Three-photon population imaging of subcortical brain regions

This file contains all reviewer reports in order by version, followed by all author rebuttals in order by version.

Version 0:

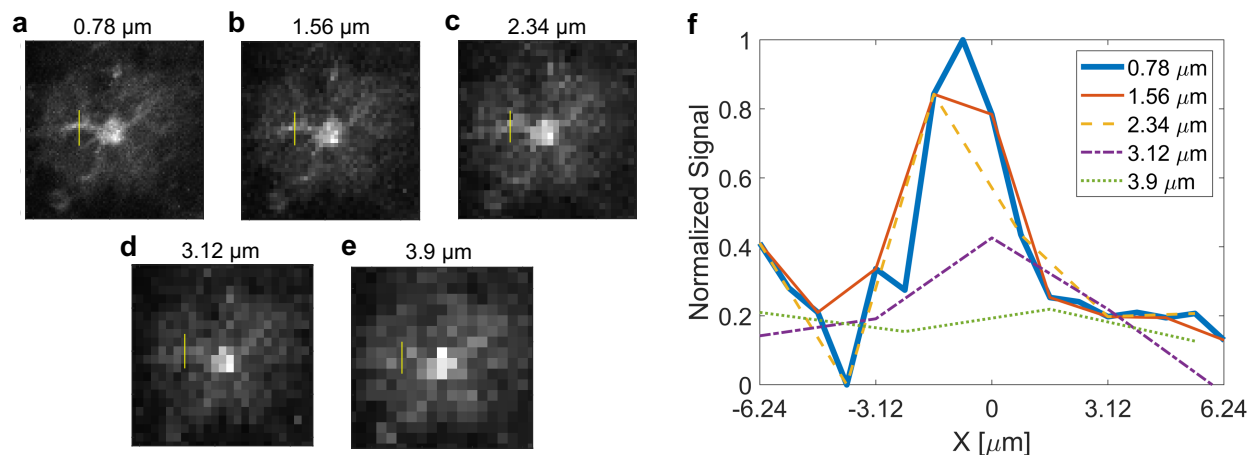
1. The sparse sampling approach leads to a gain in FOV, frame rate and SNR, but the imminent loss in spatial resolution could be undesirable for certain applications, especially those requiring visualization of fine cellular structures, such as axons or fine cellular processes. On this note, could the authors show and discuss how their system performs apart from imaging neuronal somata. For example, by imaging astrocytic processes or capillary networks? Also, comment on this problem in the discussion.

The reviewer raises an important point: multiphoton imaging encompasses many applications beyond calcium imaging of neuronal somata. To address this concern, we performed additional experiments and analyses and added a new paragraph to the discussion section.

In order to demonstrate this in experimental data, we performed new experiments in which we imaged mice with GCaMP-labelled astrocytes and studied the effects of focal spot spacing on the retrieved width and contrast of their processes. Focal spot spacings that obeyed the Nyquist criterion generally correctly resolved the width and preserved contrast (Figure S3 in Supplementary Note 1.3). Since there is variability in the size of biological structures, it is best to run a check on acquired data, as detailed in Supplementary Note 1, to optimize the focal spot spacing and frame rate to the desired segmentation fidelity.

1. Added section 1.3 in Supplementary Note 1, which walks the reader through the rationale described above and illustrates it with the astrocyte example.
2. Added Fig. S3 in Supplementary Note 1, copied below.
3. Rearranged Supplementary Note 1 into sections to improve readability.
4. Added the following paragraph in the discussion section:
“While this work focuses on calcium imaging of neuronal somata, there are many other applications of in vivo multiphoton imaging. For imaging of finer cellular

structures, focal spot distances smaller than 4 μm are required. A key advantage of LIFT is that it allows users to select the focal spot spacing, field of view, and frame rate best suited to their application (as in Supplementary Figs. 1a, 9, and 10). However, these three parameters are inherently coupled through a trade-off dictated by the optimal repetition rate for a given imaging depth. Thus, users can achieve finer spatial sampling by reducing either the FOV size or the frame rate. The optimal focal spot distance and frame rate for a particular application can be determined according to the procedures detailed in Supplementary Notes 1.1-1.3.”

Reviewer Fig. 1: Data from Fig. 4f in the previous (panel a) and revised (panel b) versions of the manuscript. Arrows point to specific examples of neurons that appeared elongated in the previous version.

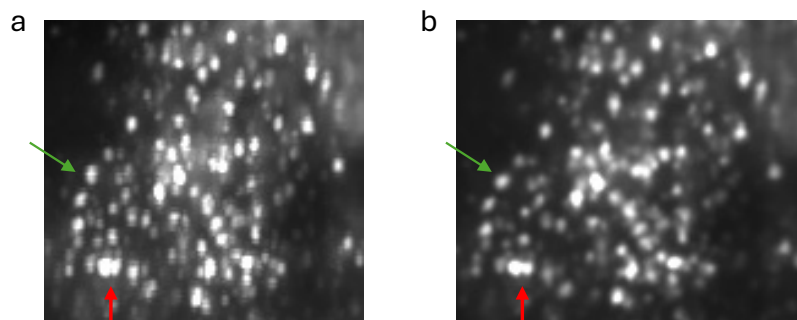
5. Please comment on the elliptical shape of neurons in Fig. 4.

We thank the reviewer for calling our attention to this matter. When looking at the structural stack (supplementary video 1), one can observe that some neurons, particularly those in the CC, are in fact a bit elongated (this corresponds to Fig. 4c). The hippocampal neurons, however, are mostly round but appeared a bit elongated in the previous version of Fig. 4. To correct this issue we implemented three changes to our processing/plotting pipeline:

1. We implemented background removal prior to the denoising of our time series. The background arises due to a slight asymmetry in the motion of the galvanometer, which creates an alternating line pattern in the direction of the fast axis (the vertical

2. We improved the accuracy of our unwarping algorithm to better correct the edges of our FOV. Inaccuracies in unwarping can elongate neurons along the fast axis as well.
3. We replotted all data so that the axis ratio is more accurate.

In Reviewer Fig. 1 below, we show a comparison of the shape of the neurons from the CA1 region in the previous version of Fig. 4f (panel a) and the revised version (panel b), showing improved neuron morphology. Pairs of arrows of the same color show examples of neurons that appeared elongated previously and no longer do.

Changes to the manuscript: We reprocessed and replotted all our datasets with this issue.

Reviewer Figure 2: (a) A fluorescent grid slide imaged with LIFT before unwarping. (b) Same image, after unwarping.

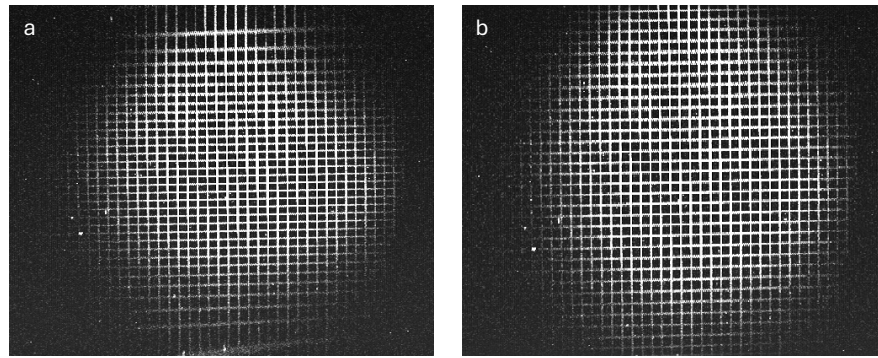
- Imaging on turnaround and unwarping. In Extended Data Fig. 3, the authors show the beam position and corresponding spot spacing across the scan. This plot is presumably derived from the galvanometer position-feedback signal, combined with the known scan-relay geometry to convert angle to lateral position. Stating this explicitly (even briefly in the caption of Extended Data Fig. 3) would help clarify what was measured and how the plot was generated.

Additionally, while the manuscript notes that imaging during the turnaround region is included, the implementation details are limited. It would be useful to expand on how pixel indices are remapped to their correct spatial coordinates (using the known position-versus-time waveform), the unwarping part.

The beam positions shown in Supplementary Fig. 11 (previously Extended Data Fig. 3) were derived by imaging a calibrated grid slide with our x-galvo waveform, measuring the

resulting FOV from the grid spacing, and scaling the waveform extrema to match the experimentally measured FOV. We then validated these estimated positions by using them to unwarp the grid-slide image, which restored the expected regular grid geometry and confirmed that the estimates captured both the scan extent and local spatial nonuniformity. Since unwarping grid-slide images with this beam position data produced satisfactory results (Reviewer Fig. 2), we assumed that the drive voltages and position-feedback voltages were sufficiently similar for this purpose and did not proceed to measure the position-feedback signal, which presented some technical difficulties.

Changes to manuscript: To clarify this in the text, we added the sentences “Beam positions were determined from the x-galvo drive voltages using an empirical FOV calibration from grid-slide images. The drive-voltage limits were mapped to the measured FOV boundaries. The computed beam positions were validated by unwarping distorted grid images and recovering the expected regular grid geometry.” to the caption of Supplementary Fig. 11.

This was indeed not fully explained in the text. To unwarp, we used the known pixel locations from the above calculation. However, instead of interpolating the image onto a regularly spaced grid, which can introduce artifacts due to the interpolation algorithm and due to the variability in SNR across the corrected pixels, we split the counts in each pixel between neighboring corrected pixels. We weighted the contribution to each corrected pixel according to how the position of the old pixel falls on the new grid. For example, if an old pixel was remapped to pixel 120.4 in the new grid, then 60% of the counts it contains would be assigned to pixel 120 and 40% to pixel 121.

Changes to manuscript: We added the sentence “The denoised time series was unwrapped to correct for the nonlinearity of the galvanometer motion, using the known pixel positions on the sample (Supplementary Fig. 11). To unwarp, pixel intensities were remapped onto a uniformly spaced grid by splitting each pixel’s contribution between neighboring corrected pixels with appropriate weights (see provided code).” to the methods section.
